The National Board of Boiler and Pressure Vessel Inspectors

SUBJECT: National Board Audit as Requested by the State of Ohio, Division of Boiler Inspection, of the ASME Code Related Construction of the William H. Zimmer Nuclear Power Plant, Moscow, Ohio

INTERIM REPORT

SHEET 1 OF 2

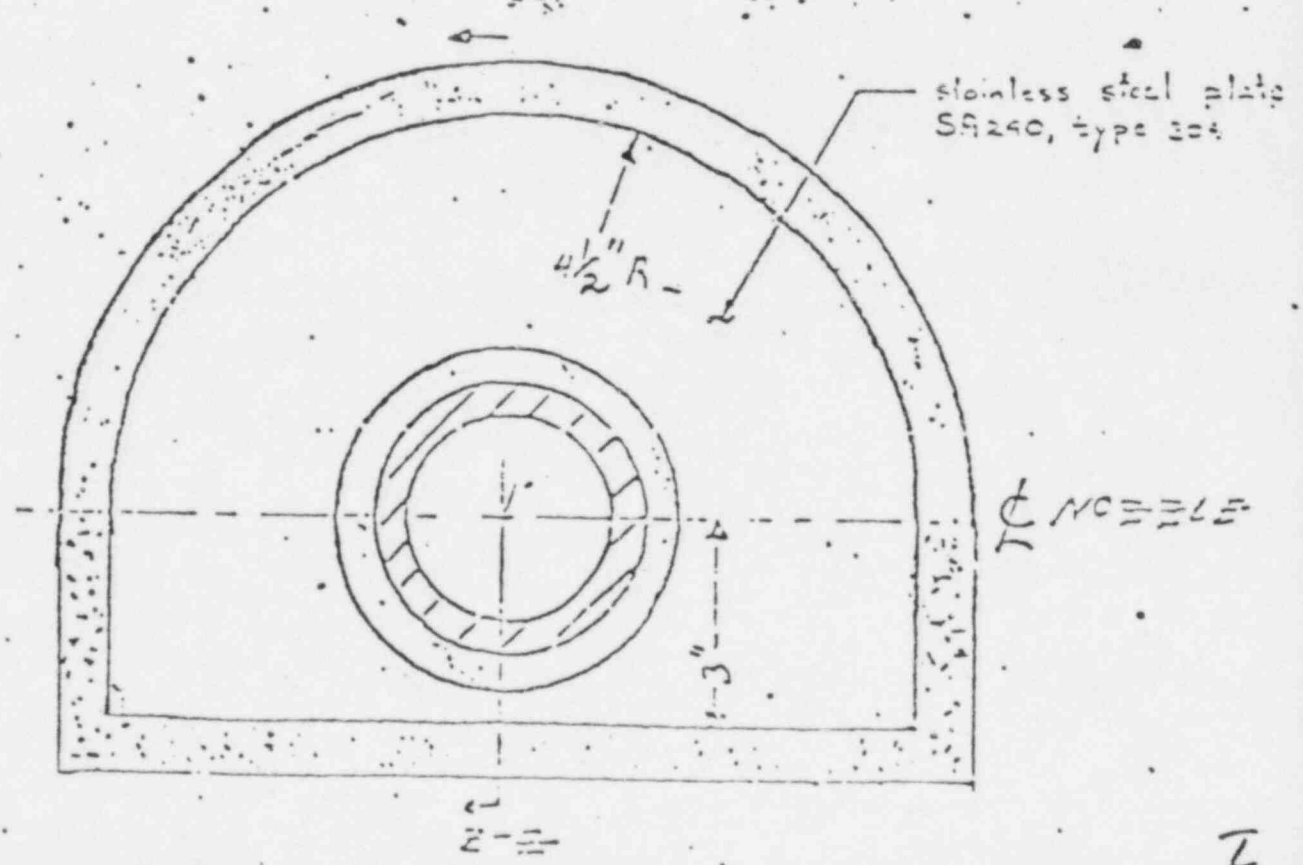
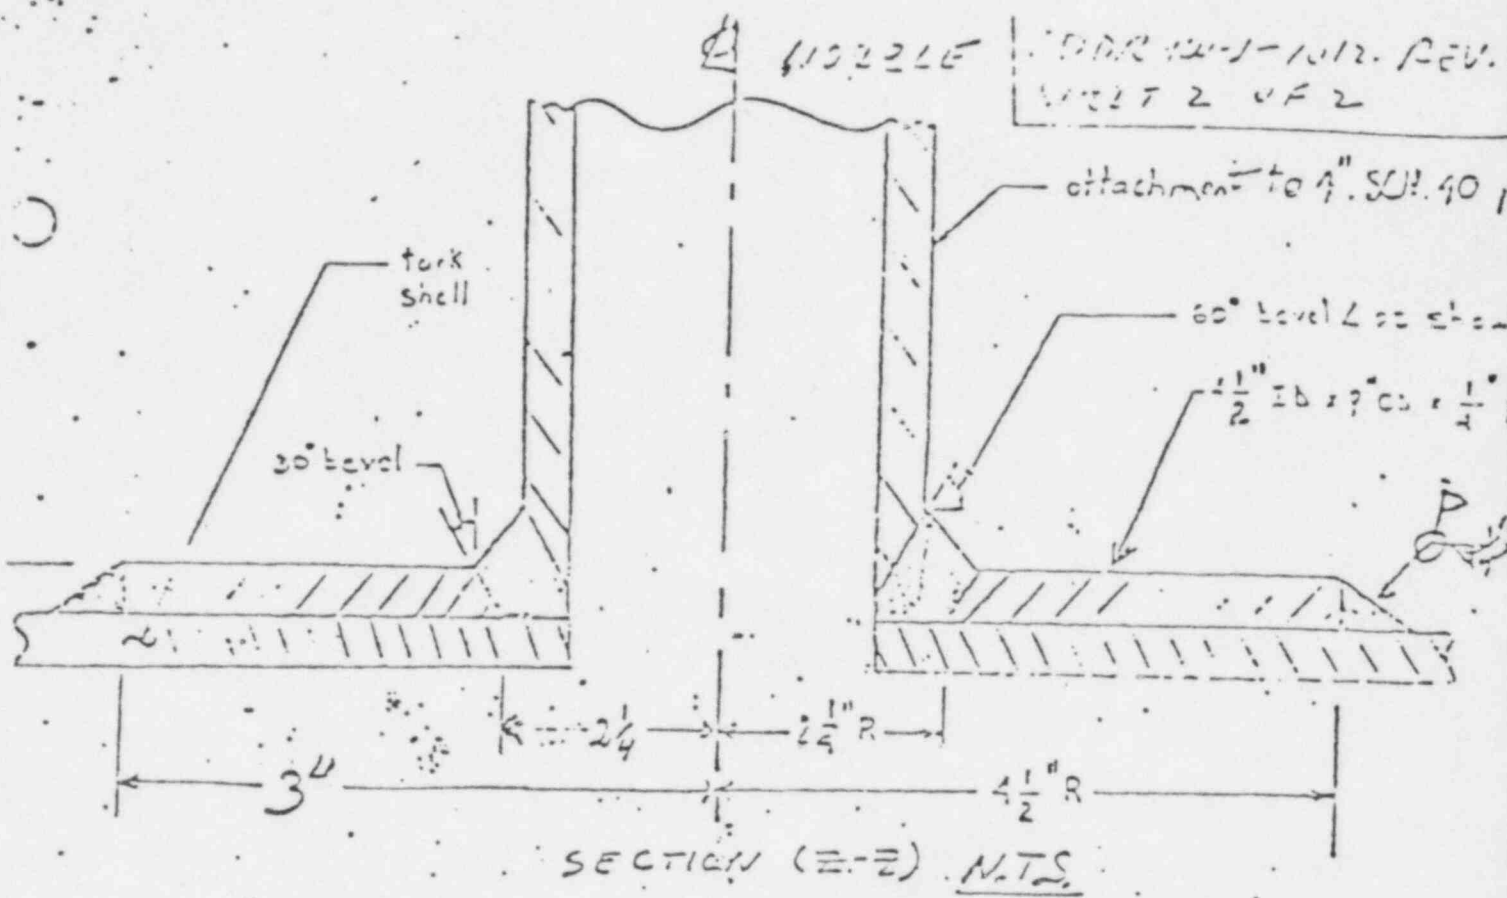
This revision is to replace sheet 2 of Revision 0, sketch showing the Sargent & Lundy design for enlarging the S&L pump suction nozzle. The previous sketch did not take account of the tank physical layout.

Engineering is to advise as to acceptability of the reduced reinforced area per the attached revised S&L sketches.

FIELD DEVIATION DISPOSITION REQUEST	DATE OF ISSUE	FDDR NO. <u>KN-1-1012</u>
		REVISION <u>3</u>
		SHEET <u>1</u> OF <u>2</u>

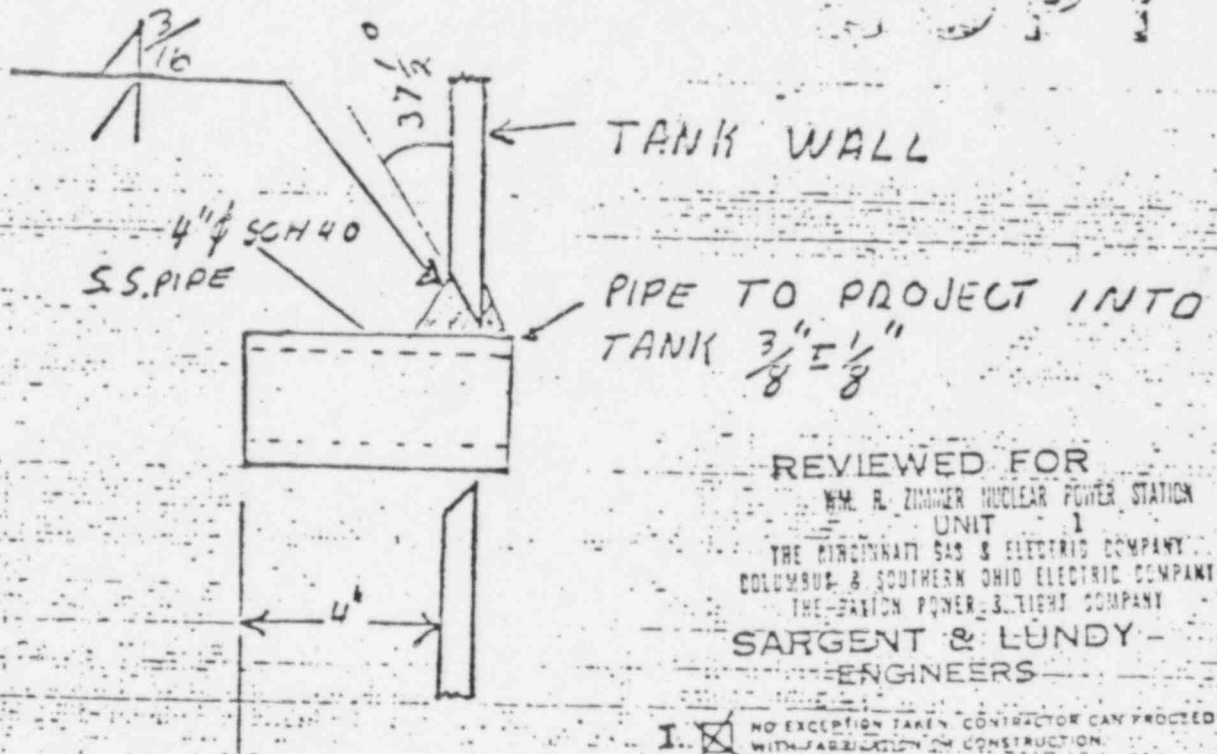
Revision 2 to the FDDR would have required boring the I.D. of the pipe. This is difficult to perform per the constructor. Therefore, the revised design proposed is per this FDDR KN-1-1012 Rev. 3 Sheet 2.

Engineering is to advise acceptability of the revised nozzle detail per sheet 2.

II DELETE ITEMS 3, 4 & 5 ON PAGE 10 OF
 FDDR-KN-1-1012-REV 2

III INSTALL NOZZLE AS BELOW.
